Access Compliance Report

Public Rights-of-Way

Intersection ID: 18387	Main Street: BURTONWOOD_CR	Cross Street: MONROE_RD	Location: SE
ADA ID: 667A2426EA5D	Ramp Type: PerpDiag	Initial Pass/Fail: Fail	Overall Compliance: No
Severity Score: 37.5			
Codes/Mitigation Info/Possible Solution		Field Measurements/Component Compliance

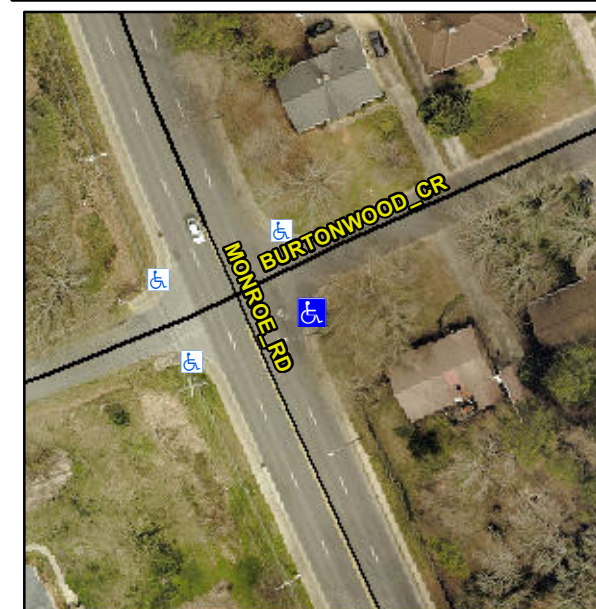
Not Found, R304.2.2, R304.5.3

Compliance	Description	Data	Compliance	Description	Data
N/A	Ramp Length (in)	58.0	No	Ramp Slope (%)	10.6
Yes	Ramp Width (in)	48.0	No	Ramp XSlope (%)	7.2
N/A	Flare Type LT	N/A	N/A	Flare Type RT	N/A
N/A	Flare Slope LT (%)	N/A	N/A	Flare Slope RT (%)	N/A
N/A	Flare Traversable LT?	N/A	N/A	Flare Traversable RT?	N/A
N/A	Landing Length (in)	N/A	N/A	DWS Provided?	N/A
N/A	Landing Width (in)	N/A	N/A	DWS Contrast?	N/A
N/A	Landing Slope (%)	N/A	N/A	DWS Length (in)	N/A
N/A	Landing X Slope (%)	N/A	N/A	DWS Full Width?	N/A
N/A	Landing Curb? (Y/N)	N/A	N/A	DWS Offset (in)	N/A
N/A	Shared Landing?	N/A			
N/A	Gutter Ponding?	N/A	N/A	Gutter Slope (%)	N/A
N/A	Gutter Lip Ht (in)	N/A	N/A	Gutter X Slope (%)	N/A
N/A	Painted X Walk1?	No	N/A	Painted X Walk2?	No
	X Walk 1 Direction	To N		X Walk 2 Direction	To W
N/A	X Walk 1 Width (in)	N/A	N/A	X Walk 2 Width (in)	N/A
	X Walk 1 Slope (%)	3.8		X Walk 2 Slope (%)	0.8
	X Walk 1 X Slope (%)	0.1		X Walk 2 X Slope (%)	4.5

Remove & Replace Curb Ramp With Two New Directional Ramps or Equivalent.
